MONTGOMERY COUNTY HISTORIC PRESERVATION COMMISSION
STAFF REPORT

Address:	7101 Poplar Avenue, Takoma Park	Meeting Date:	10/08/2025
Resource:	Non-Contributing Resource Takoma Park Historic District	Report Date:	10/01/2025
Applicant:	Roberta Valente and Neil Goldsman Elena Zenke (Agent)	Public Notice:	9/24/2025
Review:	HAWP	Tax Credit:	No
Permit Number:	1131967	Staff:	Devon Murtha
PROPOSAL:	Solar panel installation

Figure 3: The site plan (left) shows the proposed solar panel locations and the building's relationship to the public right-of-way along Poplar Avenue. The roof plan (right) shows the proposed location of the solar panels and the equipment location.

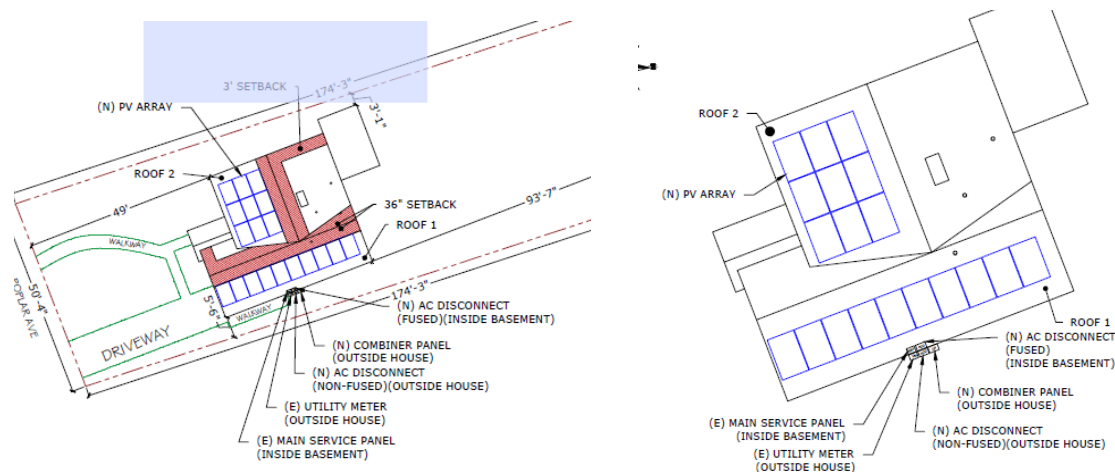
Both proposed arrays will be installed on the non-historic second story roof, which is a tertiary preferred location. The arrays will be visible from the right-of-way from Poplar Avenue from some vantage points but are relatively inconspicuous due to the height and pitch of the roofs (*Figure 5*).

Figure 6: Shape map for the subject property.

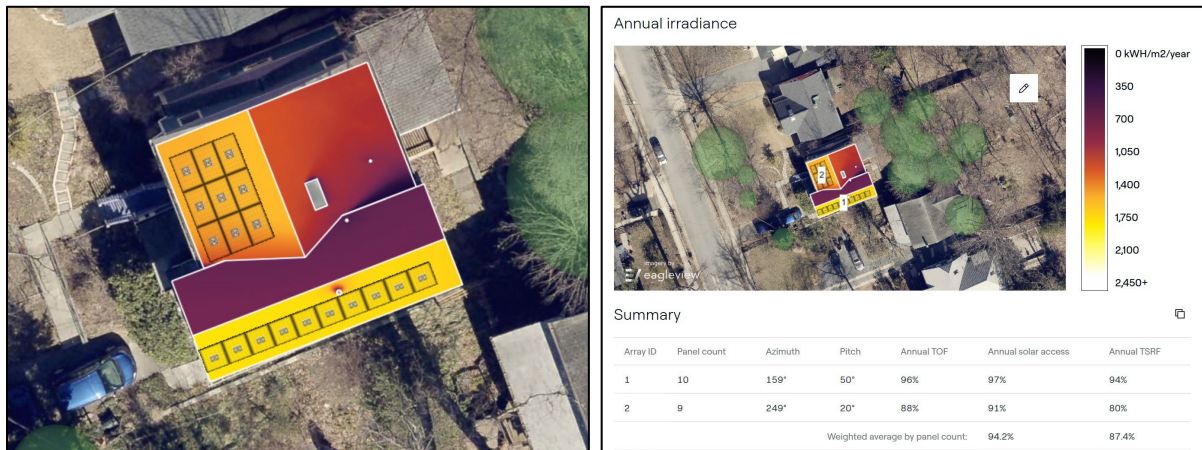
The applicant submitted compelling justification for the placement of the panels. The home had an annual usage of roughly 10,702 kWh in 2024. The proposed system is estimated to generate 10,745 kWh in annual production, accounting for all the energy needs of the household. Due to the roof orientation, the panels on the south-facing side roof generate the most energy, following by those on the west-facing front. Relocating either of the arrays to the rear (east-facing) roof of the property would significantly hinder the energy capacity of the project.

PERMIT DEVELOPER	
DATE	08/25/2025
DESIGNER	OVV
REVIEWER	
SHEET NAME	
ROOF PLAN & MODULES	
SHEET NUMBER	
A-01

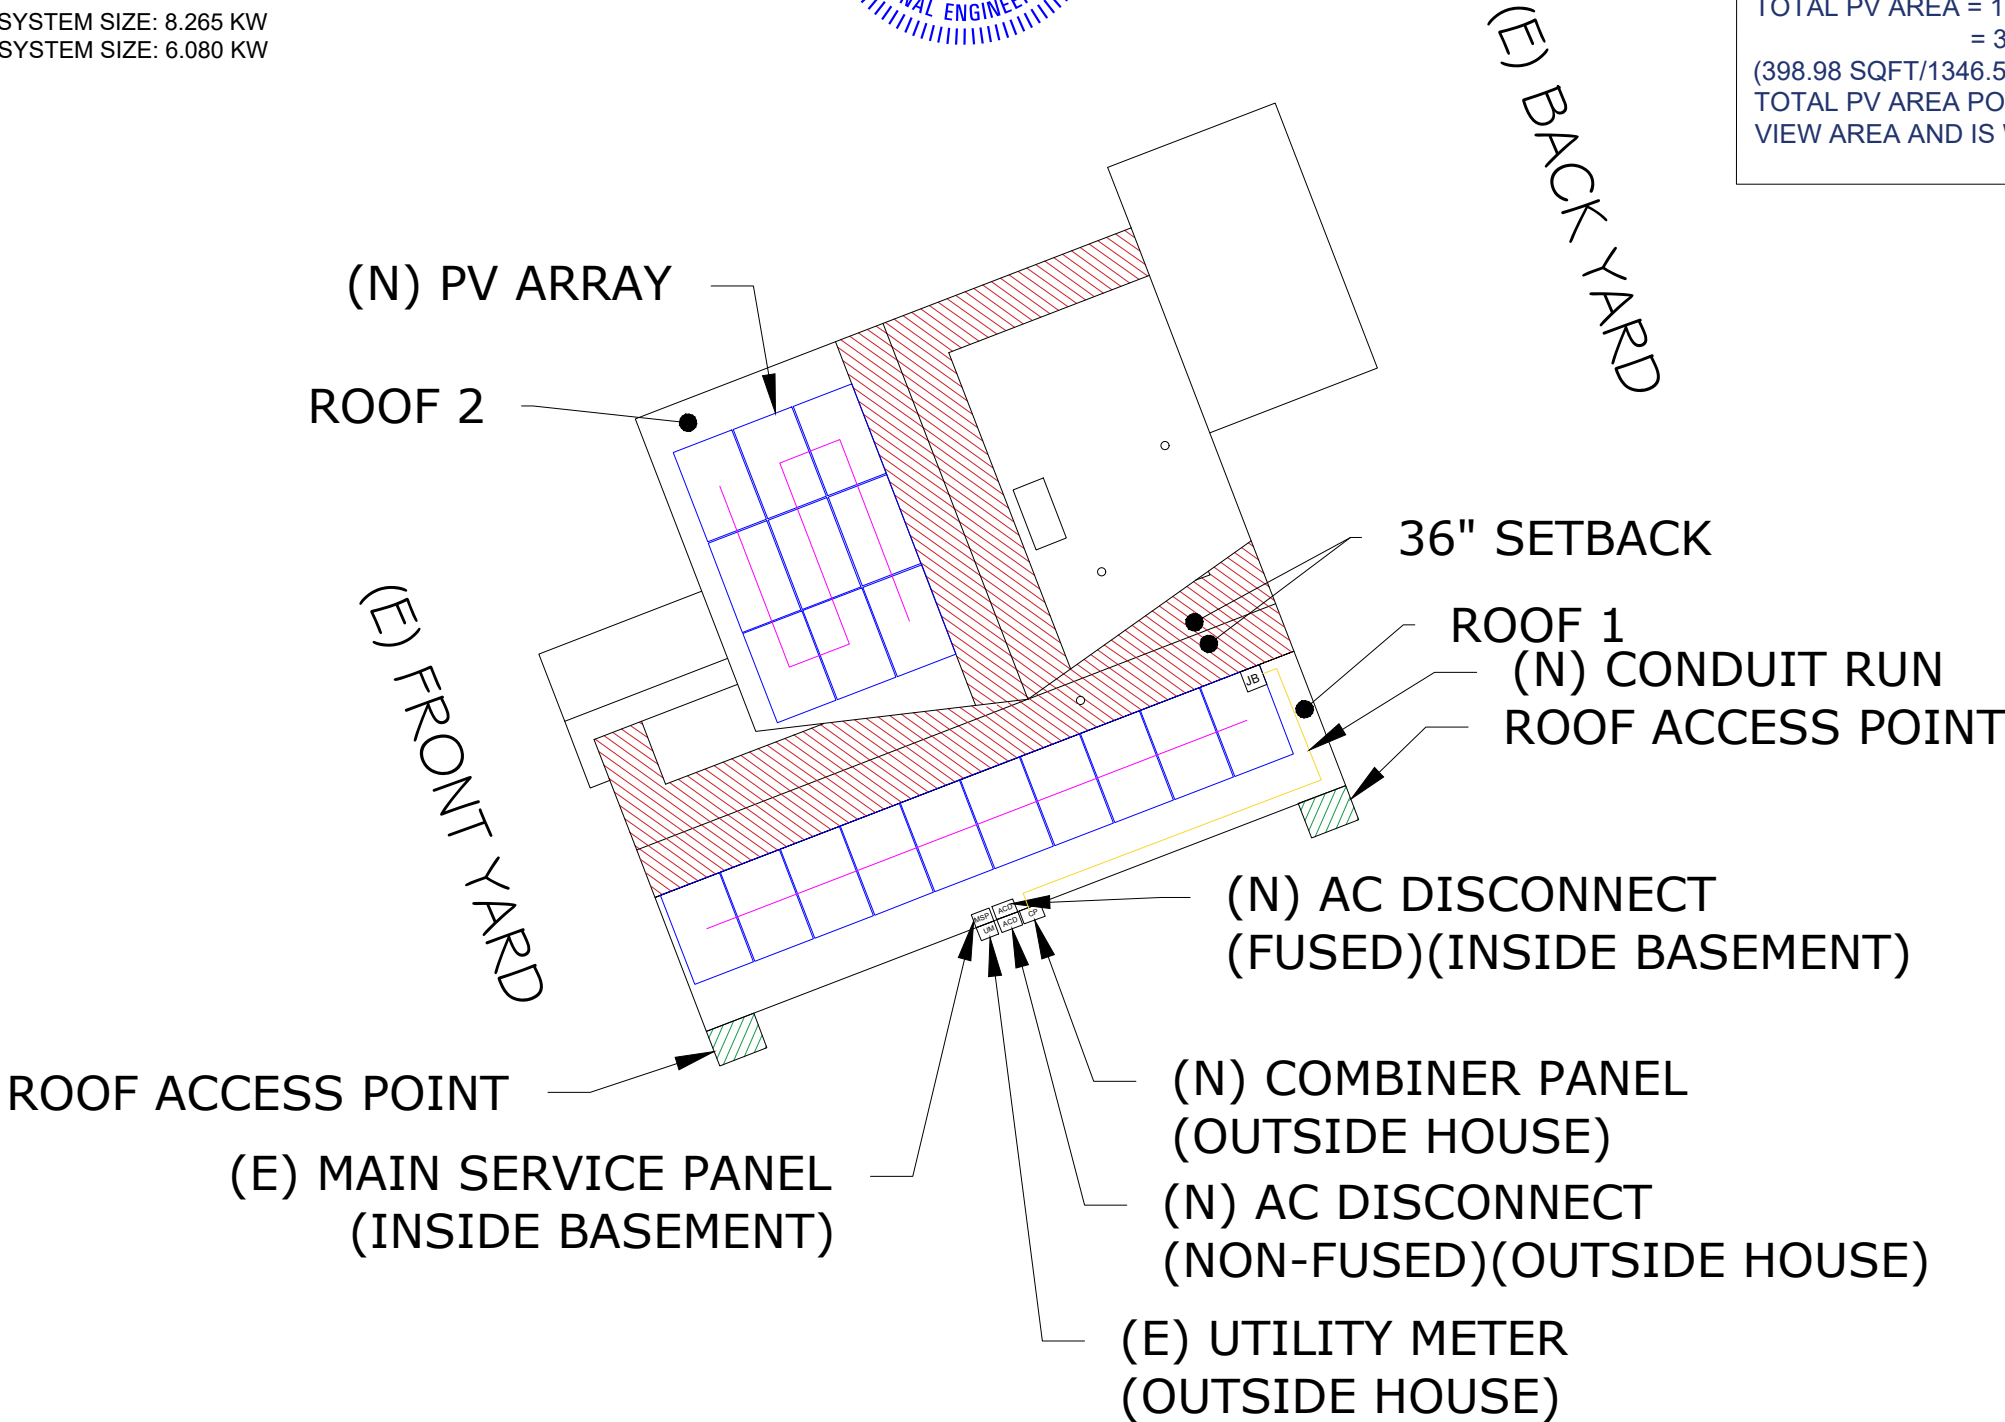
In reviewing your application, I see that you are proposing installing some panels on the front-facing main roof. The HPC policy discourages this placement - see the full policy here: <https://montgomeryplanning.org/wp-content/uploads/2021/12/Solar-Panel-Interactive.pdf>. However, the HPC can consider approval of panels on front roof slopes if the applicant provides evidence that this is the only feasible location for the panels. Please submit your justification, including
